## Chapter 1. Introduction

## 1.2 Project Overview

- To review the DPR and make improvements.
- To confirm/assess project purpose, traffic demand forecast, engineering design, cost, schedule, implementation structure, economic viability, and the like, for JICA loan appraisal;
- To confirm that environmental and social considerations of this Project is in compliance with the JICA guidelines.

Figure 3-12 Indication of Boring Location

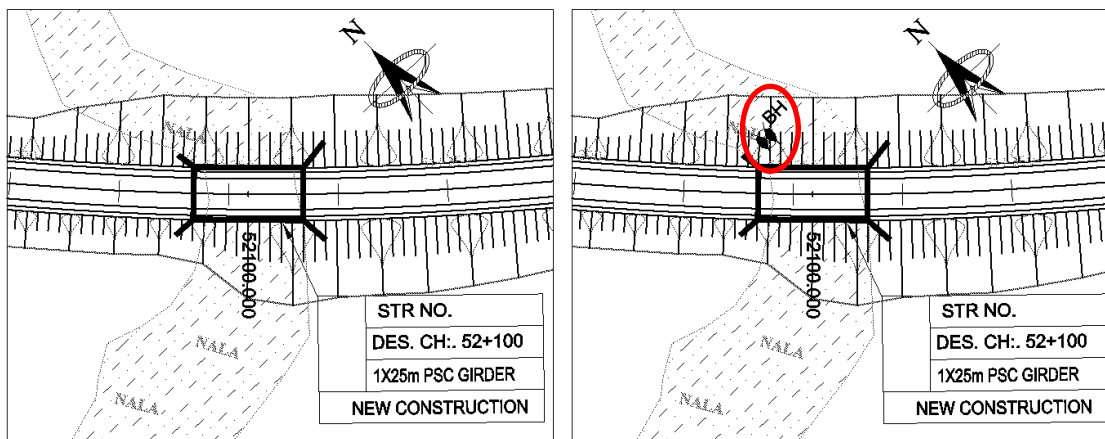
It is suggested that the bore holes shall be shown in LOCATION PLAN because their locations cannot be identified on the General Arrangement Drawings. The DPR Consultant agreed and updated on GADs.
